## **SUBJECT: ISSUE WITH HITCH PIN ASSEMBLY (2017661 REV 0)**

This Hitch Pin Assembly (JBW# 2017661 Rev 0) was used in the following larger assemblies, on units built before 02/25/2022:

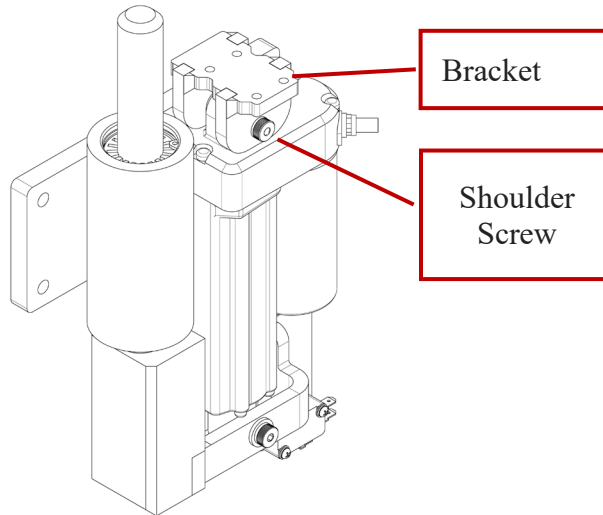
1. Remove the Shoulder Screw from the Pop-up Pin Hanger Bracket.

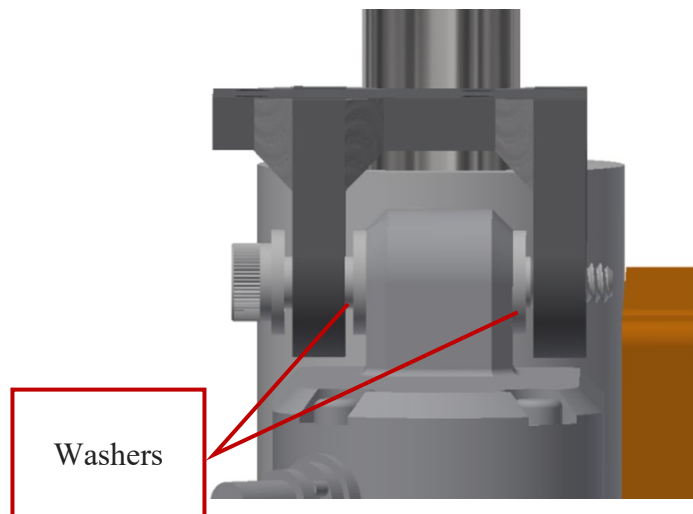
2. Reinsert the screws, adding in two washers (I.D. 0.281", O.D. 0.500", THK 0.064-.083" <https://www.mcmaster.com/98029A027/>) between the linear actuator and the bracket. Torque the screws to 29-32 in-lbs.

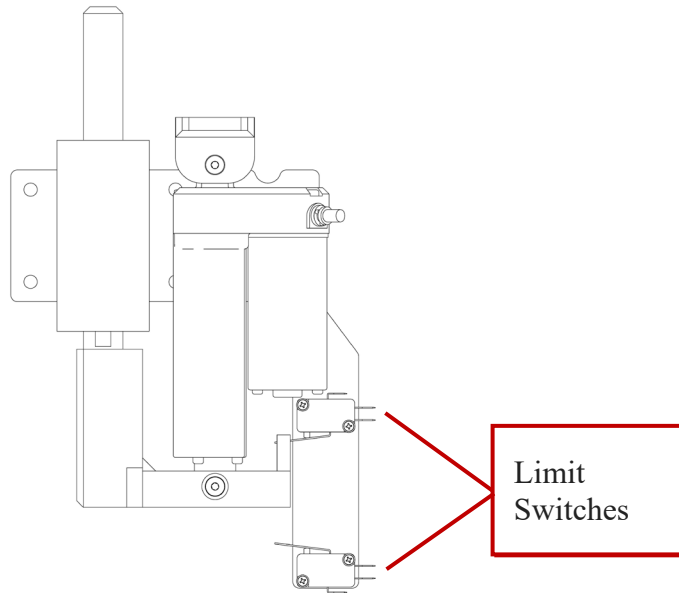
1. Remove the screws from the Limit Switch.

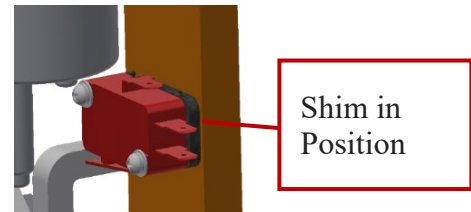
2. Place a shim (JBW# 2006214) or two washers (I.D. 0.125", O.D. 0.250", THK 0.049-.068" <https://www.mcmaster.com/98029A024/>) between the Limit Switch and Pin Guide Plate.

3. Replace the limit switch screws with  $\frac{3}{4}$ " long screws (<https://www.mcmaster.com/90272A098/>). Torque to 4-5 in-lbs.
